Item ID: D212-664-101TRN

Item Name: Crosstube Turning Detail

DART AEROSPACE LTD	Work Order:	105206
Description: Crosstube Assembly (205/212/412 High Fwd)	Part Number:	D212-664-141
Inspection Dwg: D212-664-141 Rev: D		Page 1 of 2

DRAWING NO. D212-664-141	TITLE XTUBE ASSY (205/212/412 HI FWD)	REV. D	DART AEROSPACE LTD ENGINEERING ORDER		D.E.O. NO. D212-664-141-D-1	SHEET NO. SHEET 1 OF 2	SCALE NTS
DRAWN	CHECKED	MFG. APPR.	APPROVED	DE APPR.	DATE	DATE	DATE
DATE 11.04.07	DATE 11.07.11	DATE 11.04.12	DATE 11/04/12	DATE 11.04.12	DATE 11.04.12	DATE 11.04.12	DATE 11.04.12

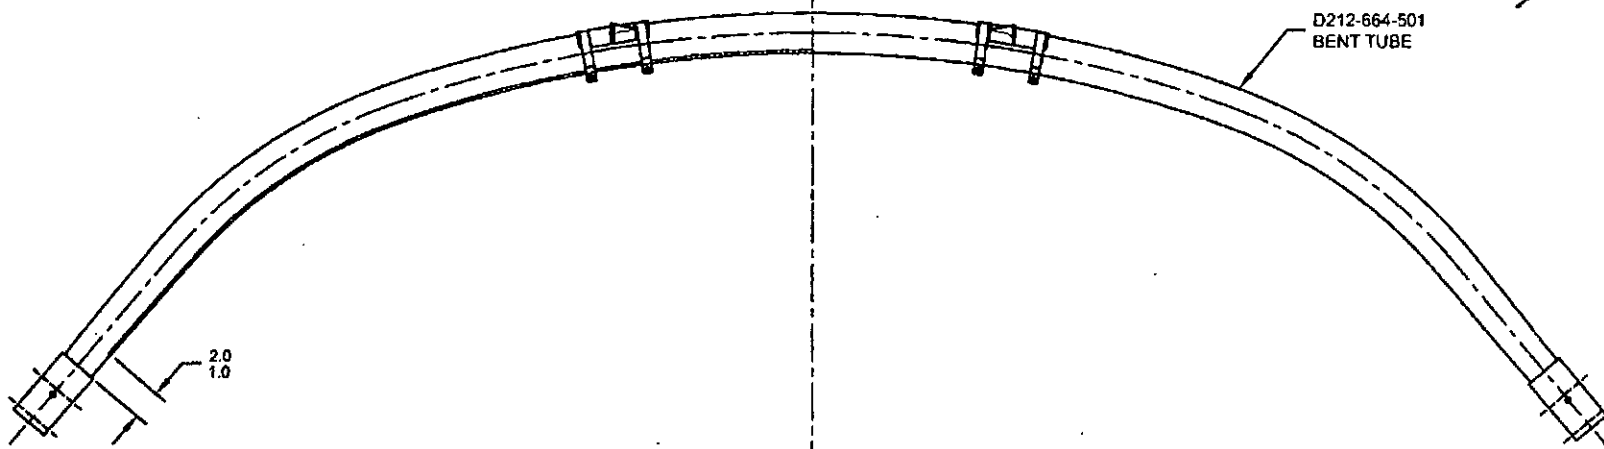
PURPOSE:
ADD AN INSPECTION WINDOW TO UNDERSIDE OF CROSSTUBE.

NOTES 2 OF SHEET 1 IS AMENDED AS FOLLOWS:

- 2) FINISH: CHEMICAL CONVERSION COAT PER DART QSI 005 4.1
PRIME INSIDE AND OUTSIDE PER DART QSI 005 4.2
MASK UNDERSIDE OF CROSSTUBE AS SHOWN (HATCHED AREA) AND
PAINT OUTSIDE PER DART QSI 005 4.2
REMOVE MASKING AND APPLY CLEAR COAT

- 2) FINISH: CHEMICAL CONVERSION COAT PER DART QSI 005 4.1
PRIME INSIDE AND OUTSIDE PER DART QSI 005 4.2
PAINT OUTSIDE PER DART QSI 005 4.2

IS:WAS:~~UNDER REVIEW~~~~11/06/13~~ECN# 11-614
11.07.28D212-664-501
BENT TUBED212-664-141/-141B
ASSEMBLY DETAILMASK AREA PRIOR TO PAINTING.
REMOVE MASKING AFTER PAINT
AND APPLY CLEAR COATC
SYM
